REMARKS

I. Drawing Changes

II. Obviousness Rejection based on Zhuang and Herzberg

Fig.1

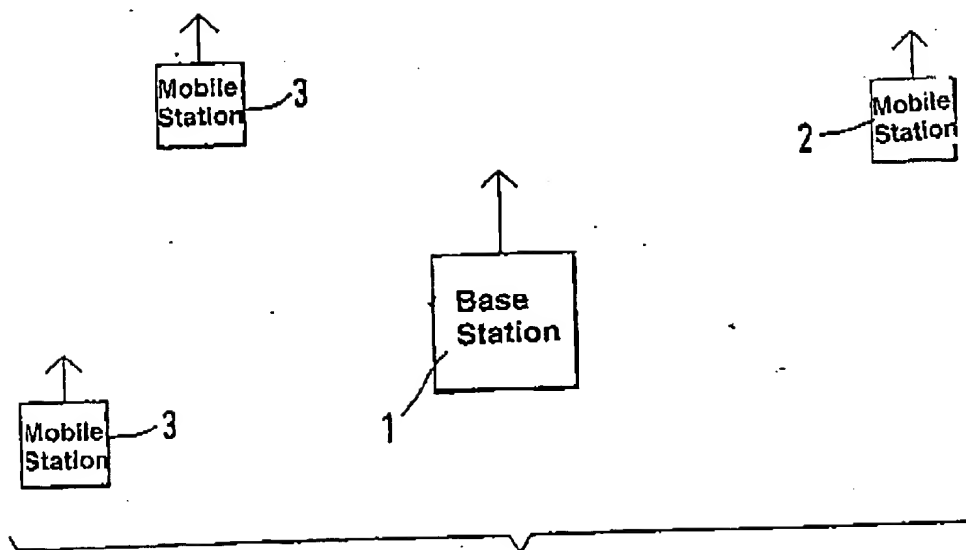
Figures 1 to 4 were not in a form that complies with U.S. Patent Office Rules, because they contained unlabeled empty boxes.

For better comprehension and to comply with U.S. Patent Office Rules drawing sheets 1 to 4 have been replaced by replacement sheets 1 to 4. The boxes in replacement figures 1 to 4 have been provided with labels based on the specification to comply with the rules for figures.
